REVIEWER 1

This study compares the flood hazard estimates generated using an event-based approach to those generated using a full suite of synthetic events, referred to herein as a response-based approach. Using Gloucester, NJ as a case study, the researchers estimate the compound hazard resulting from the joint probability distribution of 18-hr total precipitation and non-tidal residuals. From this distribution, they generate 5,000 synthetic storm events, each of which has a statistically derived spatiotemporally varying rainfall field and storm tide hydrograph (non-tidal residual + tide). From these, the authors sample 25 synthetic storm events with an Annual Expected Probability (AEP) of 1% (i.e., 'event-based') sampling from the isoline (representing maximum likelihood) and compare the estimated 1% AEP inundation map generated using the entire suite of synthetic storm events (i.e., 'response-based'). They find that the response-based approach generally generates higher hazard estimates, suggesting that selecting the 1% events based on boundary conditions alone does not generate the 1% hazard.

Figure S1 Topobathymetry from CoNED (NAD83/UTM18N)

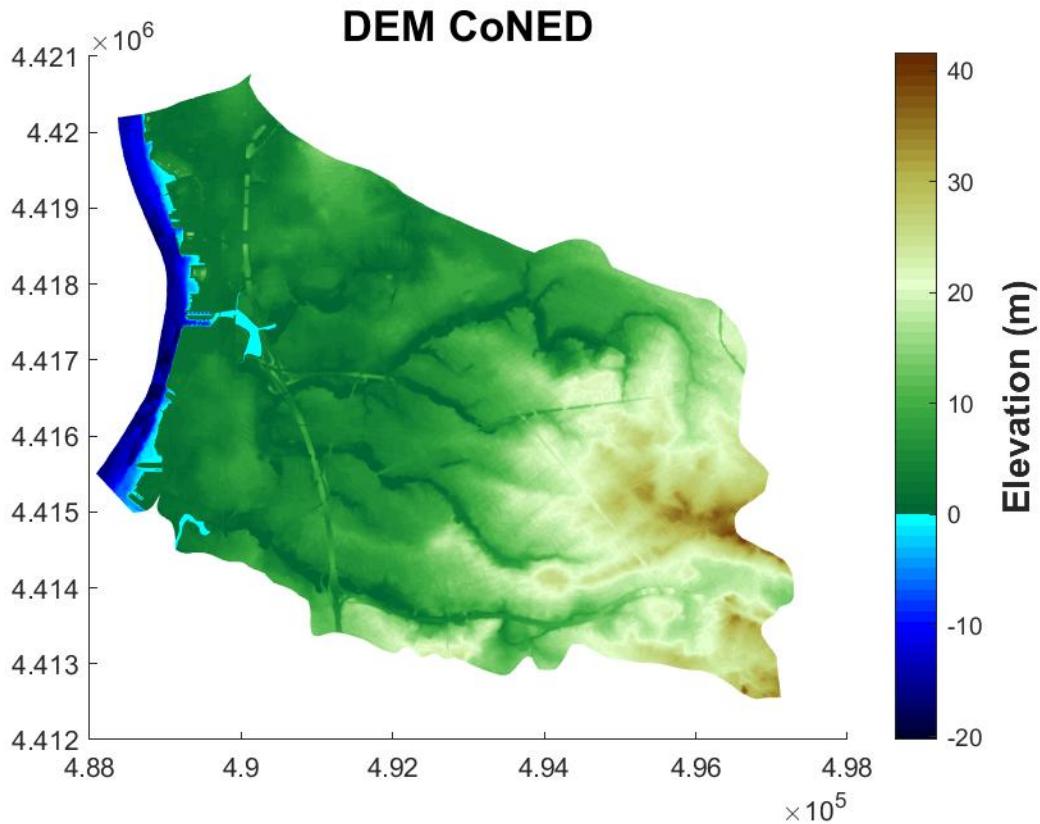
Line 208 You state that the DEM was retrieved from CoNED. Does CoNED provide an accurate estimate for the channel bathymetry for the creeks in your model domain? Channel bathymetry is a big unknown in many hydrodynamic simulations and has been shown to be critical to correctly estimating flood inundation (e.g., they are too shallow, more water will be routed over the floodplain whereas if they are too deep, not enough water will be routed onto the floodplain). If they are not well-represented in CoNED, did you make any effort to ‘burn in’ or manually adjust the depth and width of the channels in your model? If not, to what extent do you think poor channel bathymetry may impact your validation results, particularly when you have to assume no infiltration in order to match a flood event in 2009 (lines 239-251)?

CoNED is a lidar-derived topobathymetric dataset with a 1-meter resolution, and to our knowledge, it is the most current and highest-resolution dataset available for our study area. However, we were unable to find information on its accuracy in representing creek channels within our site, nor did we find any other DEMs that provide detailed information about these features or had the opportunity to collect the data ourselves. Therefore, we have not modified the bathymetry of these channels. We could only revise satellite images and street-view photos to better understand the potential depth of these channels. These sources suggest that the channels may be a few meters deep near their intersections with the Delaware River, but become much shallower and more vegetated further inland. We have included a map of the topobathymetric dataset used in the Supporting Material. As can be seen in it, the channels are represented in the DEM, though their depth may be underestimated. We have addressed this limitation, as well as the uncertainty in water depth levels around the creeks due to the exclusion of infiltration, adding:

“Although most of our study domain is urban and thus covered by impervious surfaces, we might underestimate infiltration in areas with larger amounts of vegetation such as areas around creeks. The bathymetry of the creeks might also not be accurately represented in the CoNED DEM (Fig. S1). If that was the case, combined with the exclusion of infiltration processes, our approach could overestimate floodwater depths along the margins of the creeks. “

We do not believe that the validation of the 2009 event is affected by inaccuracies in the creeks' channels since the location of the photo used for validation is in an area far from the creeks and not hydrologically connected to the creeks (at least for an event of that magnitude and that was rainfall-driven).

Figure S2 Land Cover of the study site. Note that the land cover classes have been grouped in these main classes for plotting purposes, but the original dataset contains a larger number of classes (NAD83/UTM18N)

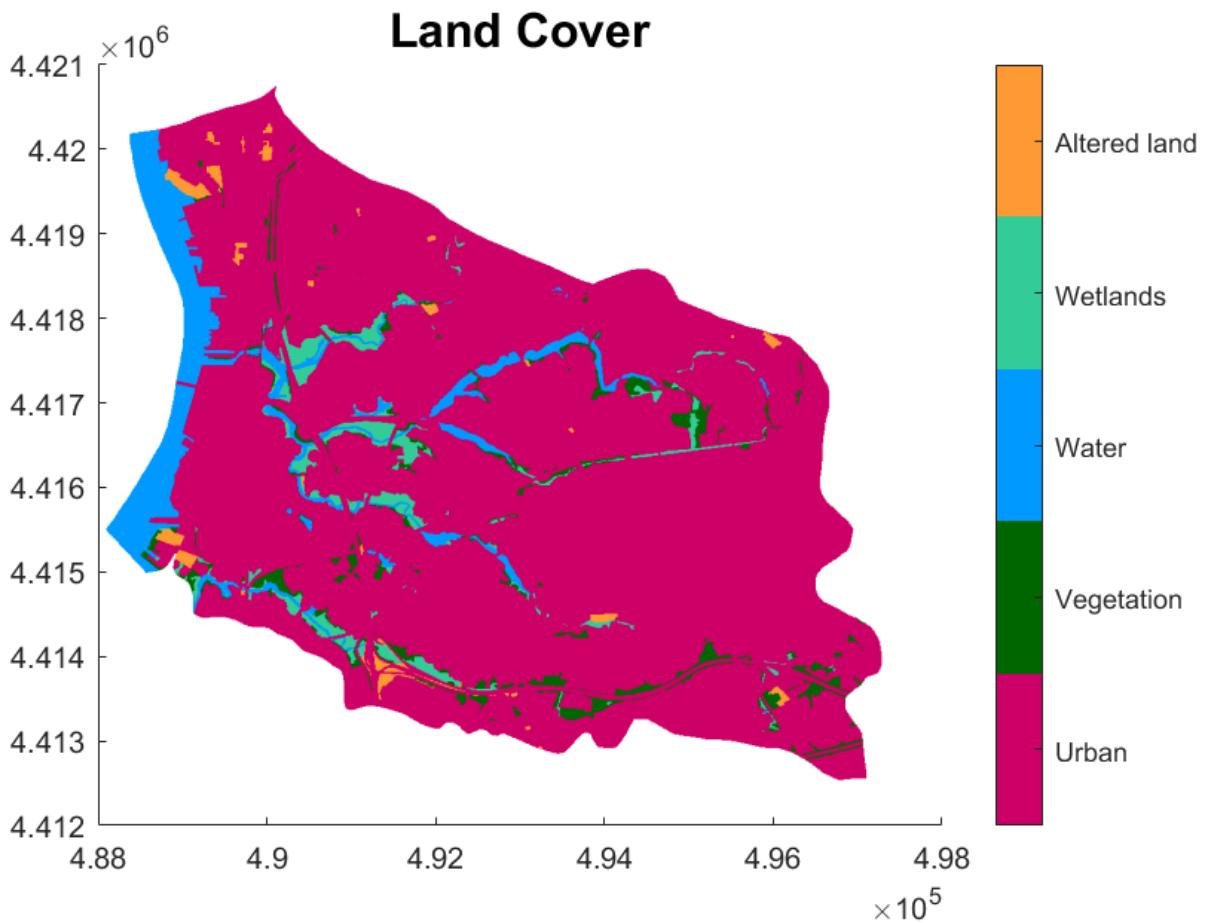
Lines 239-251 You do an excellent job of using what information you could find to try and validate the model. However, your primary focus is on infiltration and there is no discussion of whether local stormwater management (i.e., subsurface drainage) exists and whether that might contribute to error in the model performance since it can't be represented by SFINCS. There is a late reference to backwater (surcharges), but it does not come up in the validation. I would also suggest to include a description of the watershed as fully urbanized to help justify the decision to neglect infiltration.

We thank the reviewer for highlighting this important issue. In response, we have expanded the description of land cover in the study area and included a land cover map in the Supporting Information. We also address the challenges faced by municipalities within the catchments due to inadequate stormwater infrastructure, particularly the use of combined sewer systems. Additionally, we have included a note on the initial soil moisture assumption in the Curve Number method implemented in SFINCS, which presumes soils are at 50% of their total capacity, a simplification that has been shown to potentially overestimate infiltration (e.g., Nederhoff et al., 2024). These considerations have also been incorporated into the discussion of the model validation and the study's limitations.

"This, combined with the highly urbanized nature of the catchment (characterized by extensive impervious surfaces) and the inadequate stormwater system performance reported by the CCMUA, led us to exclude infiltration in the SFINCS model configuration used for all simulations in this study. At the time this study was conducted, the Curve Number method was the most advanced infiltration approach available in SFINCS (the latest release has since added the Green-Ampt method). However, as noted by Nederhoff et al. (2024), assuming that the initial soil moisture is at 50% of its total capacity can lead to an overestimation of infiltration."

“Nevertheless, the exclusion of stormwater infrastructure may have a greater impact on the results for smaller, more frequent events, potentially leading to an overestimation of flooding in cases where the existing drainage system would likely manage the runoff. However, this would have a negligible impact on the response-based estimates for the 1% AEP since the empirical distribution will not change for rare large events. “
